■ **Engineering Plastic Bearing, Flat Type, with Male Thread – Comparison of Appearance and Specifications**

The following specifications have been changed, but there are no problems with use.

■ **Hexagon Socket Depth (Male Threaded Shaft)**

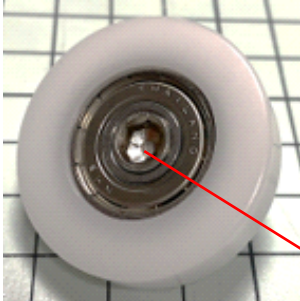
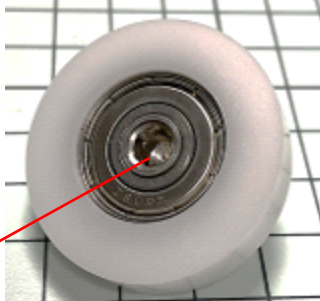
**Hex socket depth\_Screw shaft section**

The depth has been increased compared to the version before change.
